# LAND USE SERVICES DEPARTMENT PLANNING COMMISSION STAFF REPORT

**HEARING DATE: March 5, 2015**

**APNs:** 0201-043-44  
**Applicant:** Eric Sambold  
**Community:** Rancho Cucamonga/Second Supervisorial District  
**Location:** South side of Snowdrop Road, approximately 325 feet west of Robinhood Road  
**Project No.:** P201300445  
**Staff:** Chris Warrick  
**Rep.:** Bonadiman and Associates  
**Proposal:** General Plan Land Use District Amendment from Rural Living (RL-5) to Single Residential (RS-1) on 6.83 gross acres and Tentative Parcel Map 19466 to subdivide 4.85 gross acres into two parcels.

Eric Sambold  
P201300445  
APN: 0201-043-44 and 45  
Planning Commission Staff Report  
Date of Hearing: March 5, 2015

# SLOPE ANALYSIS

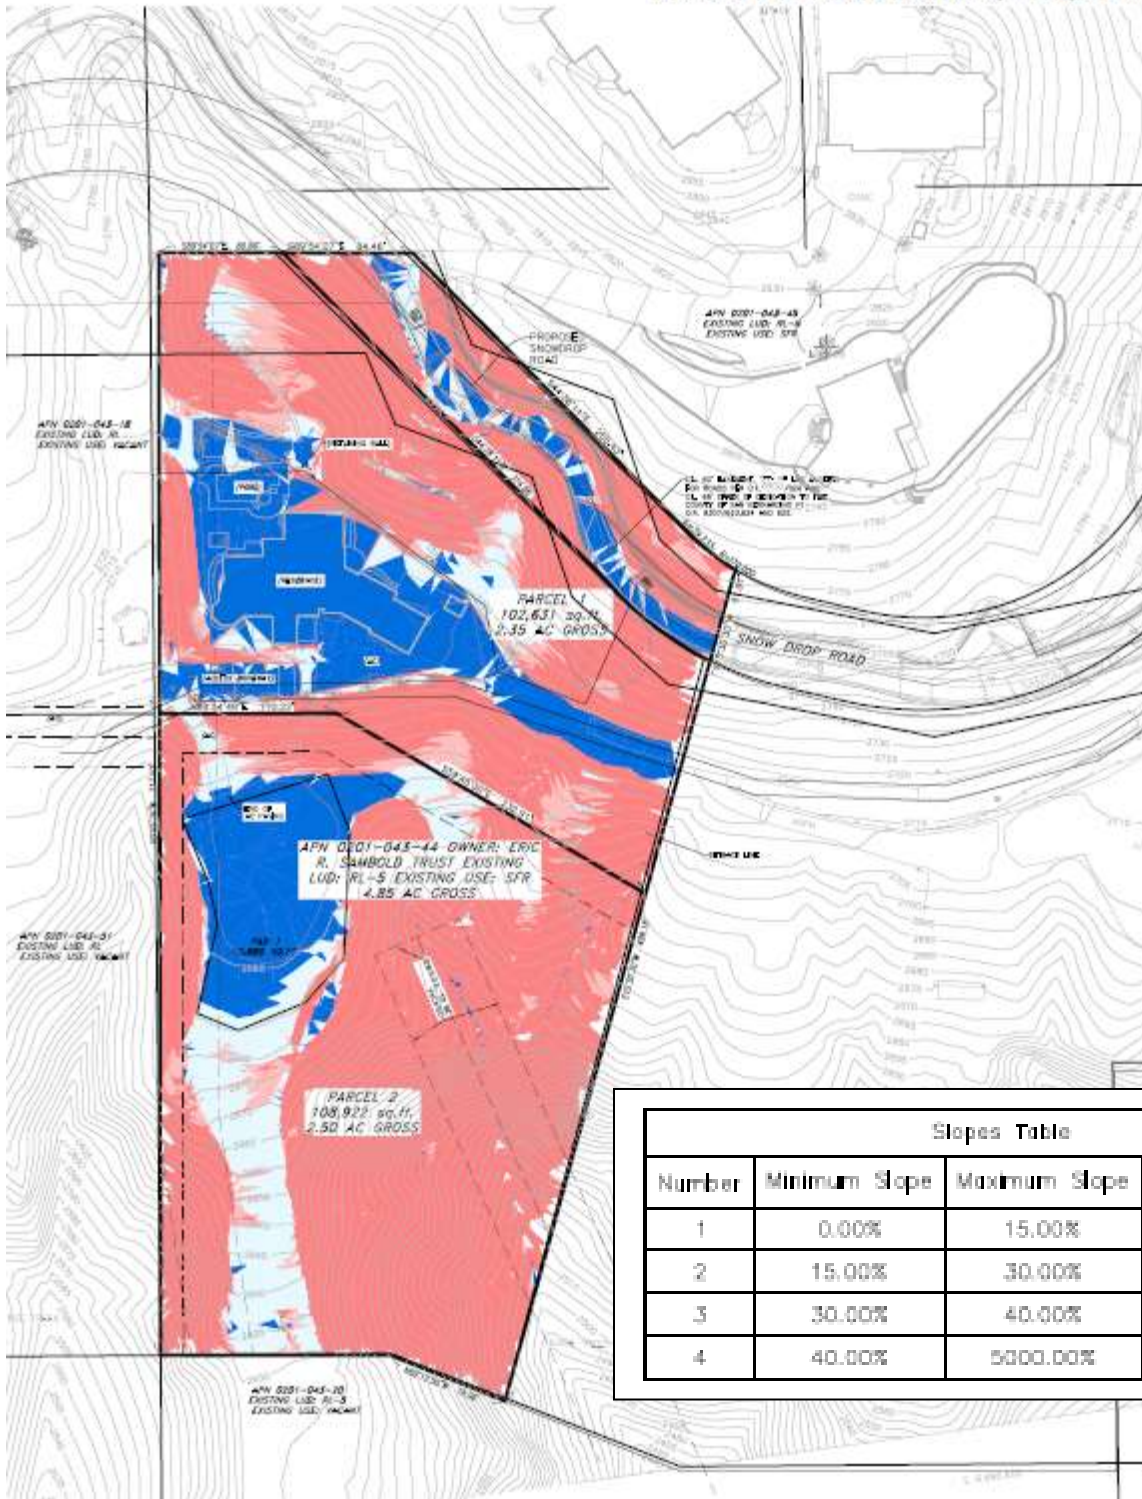
Slope Analysis. As noted above, 62% of the Project site has a grade of 40% or greater. Approximately one acre of the site contains slopes that are less than 15%. This includes the area around the existing single family house, the road bed of Snowdrop Road, and the proposed building pad for parcel 2, which is 12,880 sq. ft. The steeper slopes are in the south half of the site where the grades exceed 100% in some areas. The following is the slope analysis table provided by the applicant:

Although the City's Land Use Districts are more restrictive than the County's, they both seem to have been based on the same criteria, the natural grade of the land. The slope analysis for the site shows that 62% of the site has slopes that exceed 40% grade, and many areas on site exceed 100% grade. Based on the generally established criteria of both the County and the City, to assign lower density designations for areas with steeper slopes, it is not recommended that the subject property be rezoned with a more dense designation, especially when the current designation of RL-5 is already more dense than the City's land use designation.
